# SAN FRANCISCO PLANNING DEPARTMENT

**MEMO**

**DATE:** July 9, 2014  
**TO:** Architectural Review Committee of the Historic Preservation Commission  
**FROM:** Kelly Wong, Historic Preservation Technical Specialist – (415) 575-9100  
**REVIEWED BY:** Tim Frye, Preservation Coordinator, (415) 575-6822  
**RE:** **Review and Comment July 16, 2014 Hearing**  
**50 Fell Street**  
**Case No. 2014.0048H**

**PROPOSED COURTYARD PLAN**

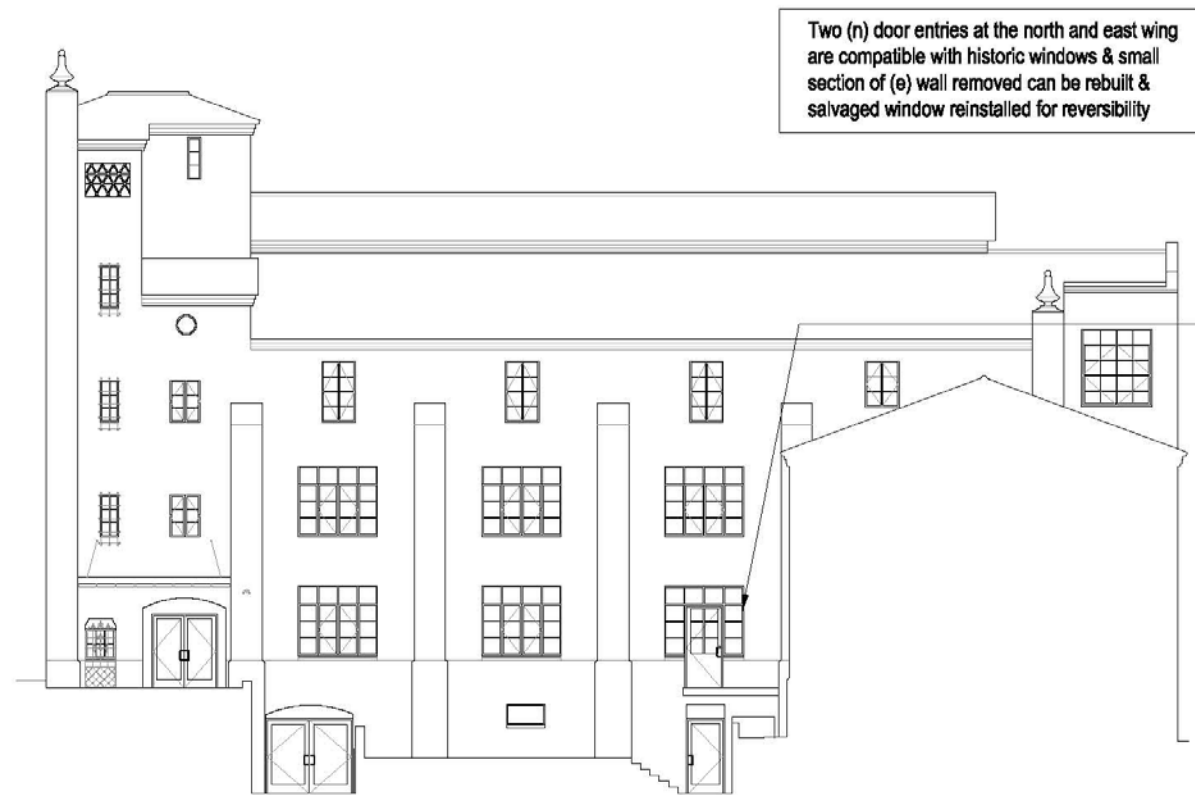
3. The Department recommends that a 3D rendering be provided to show clearly the proposed changes to the courtyard design. The Project Sponsor is to confirm that no proposed irrigation will damage the historic building and site elements.
